**Re: NR 718 Application - Soil Waste Management Plan  
Rock River Sediment Removal Project  
Janesville, Wisconsin  
BRRTS Activity # 02-54-577951**

NR 718 Beneficial Re-use exemption Request  
Rock River dredging Project  
Fill Location - JATCO Site  
544 Kellogg  
Janesville, WI

**AMENDED SOIL MANAGEMENT PLAN**  
**ROCK RIVER SEDIMENT REMOVAL PROJECT**  
**JANESVILLE, WISCONSIN**  
**BRRTS Activity # 02-54-577951**

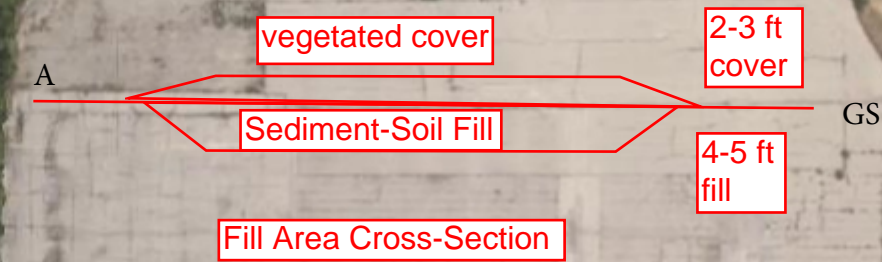
4. A map depicting the reuse area was provided. If the cap tapers off as shown on the figure it should extend beyond fill area to ensure the thickness will be protective.

*A revised cross-section showing the cap soil overlapping the excavation to minimize potential for infiltration through the fill material is attached. Soil will be compacted and amended as necessary to support a vegetative cover.*

**PROPOSED LAND  
 USE/ ZONING  
 CONCEPT 3**

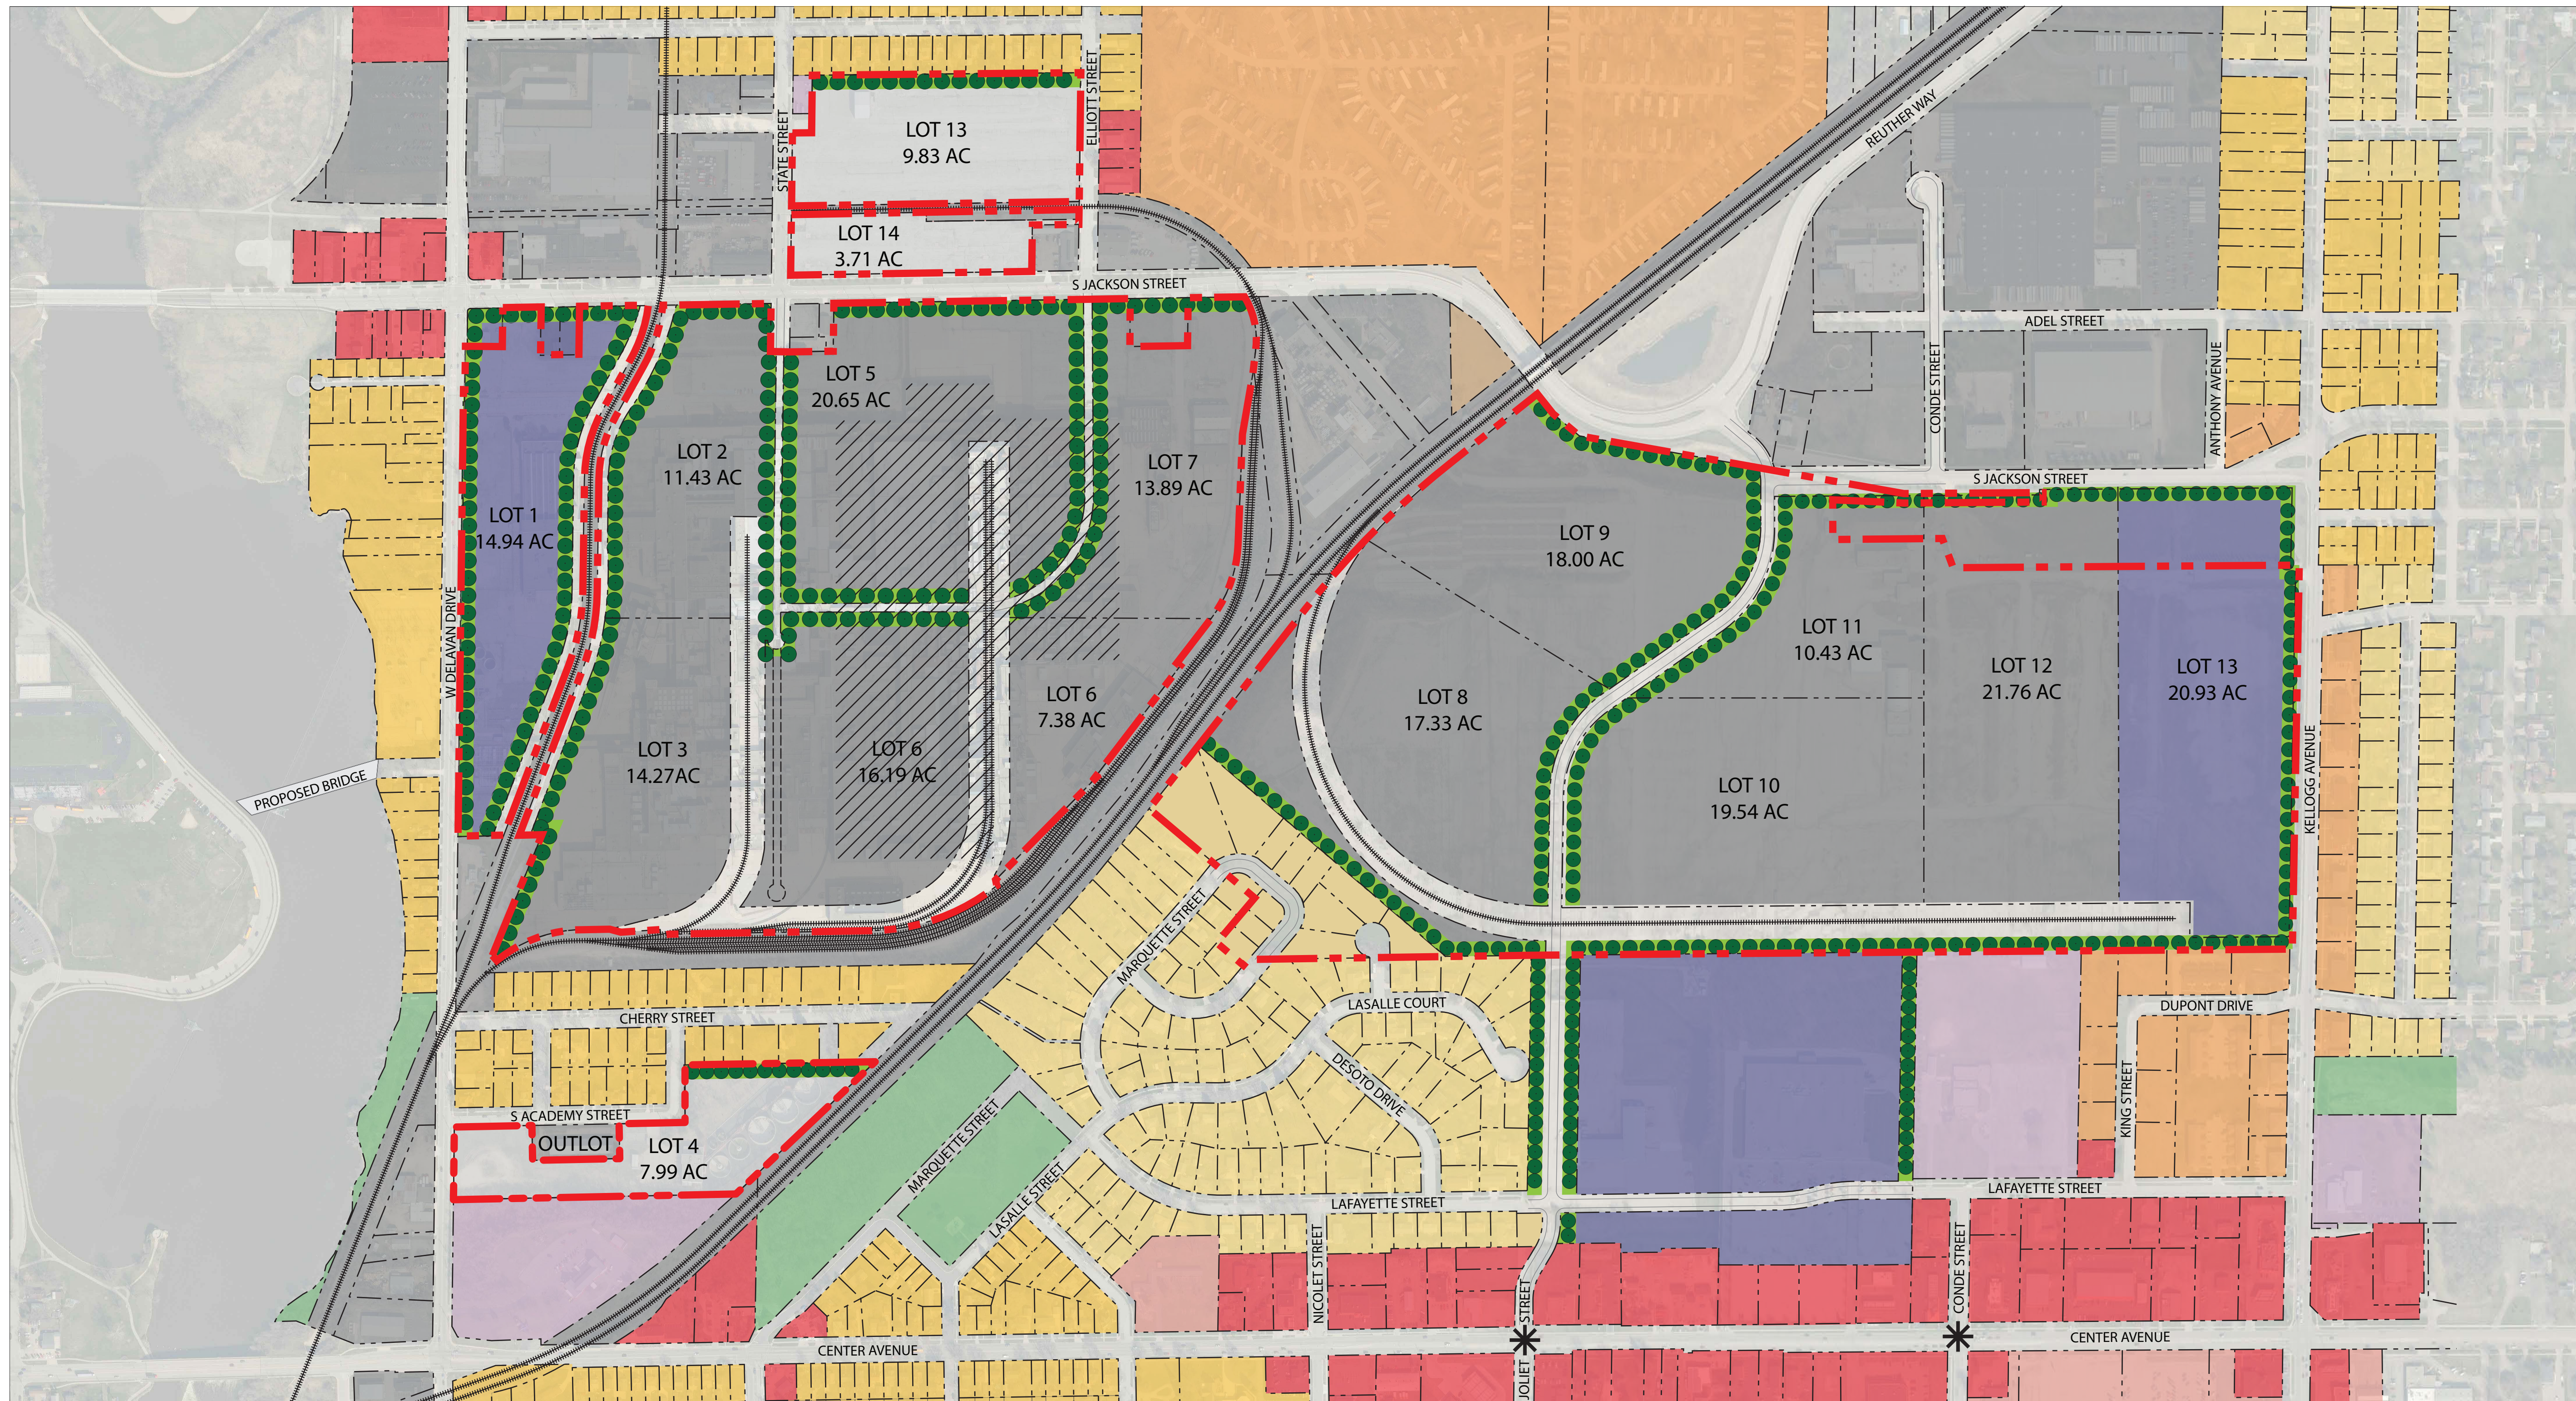
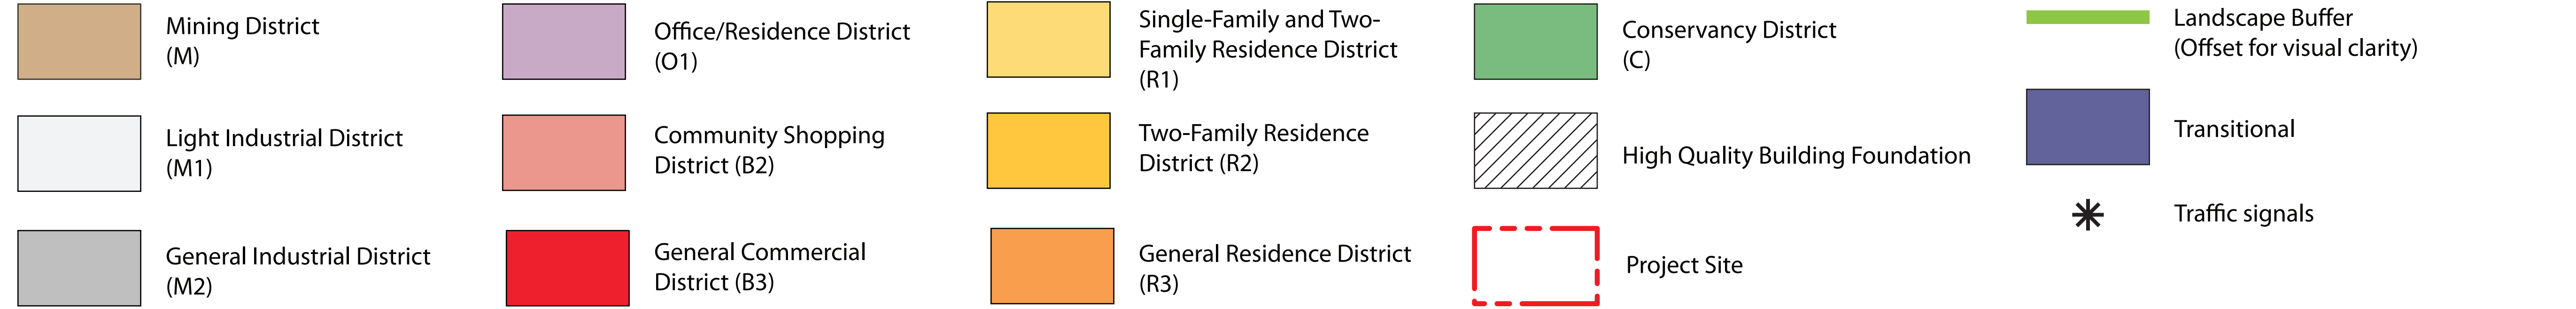
The land use / zoning plan was not included with the application, so it is unclear if requiring industrial zoning to be maintained would be an issue for this property.

*A copy of the current proposed planning is attached.*

SOIL WASTEMANAGEMENT PLAN - DECISION DIAGRAM  
1000 GENERAL MOTORS DRIVE  
JANESVILLE, WISCONSIN

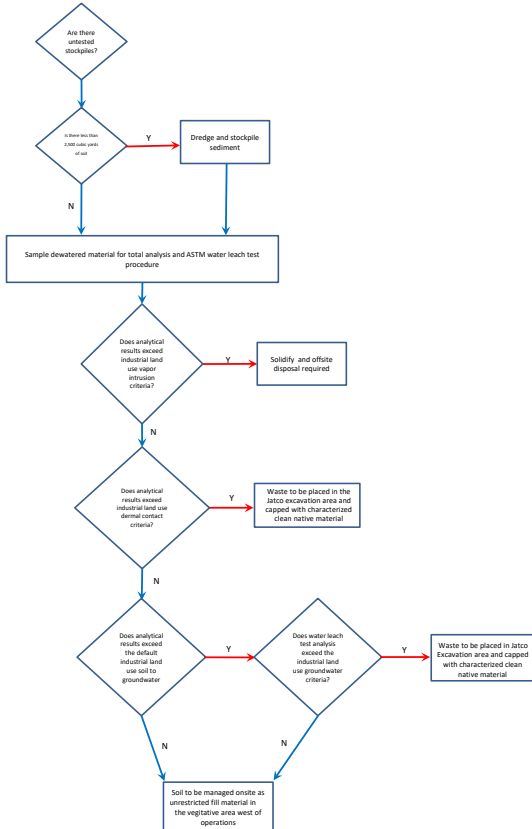
6. Provide a justification that reuse will meet requirements of NR 726.12(1)(b)1-5 (which generally means that the reuse of the contaminated soil in the proposed location will not result in harm to human health or the environment).

The analytical data provided so far indicates that the soil potentially exceeds industrial direct contact RCLs and that naphthalene has the potential to leach such that an enforcement standard could be exceeded by this compound. The flow chart included with the Application

suggests that soil with these characteristics be reused under a concrete cap or be disposed at a licensed facility. Explain how reusing the soil in the newly identified reuse area is as protective as these other strategies. The DNR does not typically consider a soil cap to be protective for preventing groundwater contamination.

*See attached revised decision tree for soil characterization, existing and proposed continuing obligations that include a soil management plan, and a cap maintenance plan demonstrating the remaining level of contamination does NOT:*
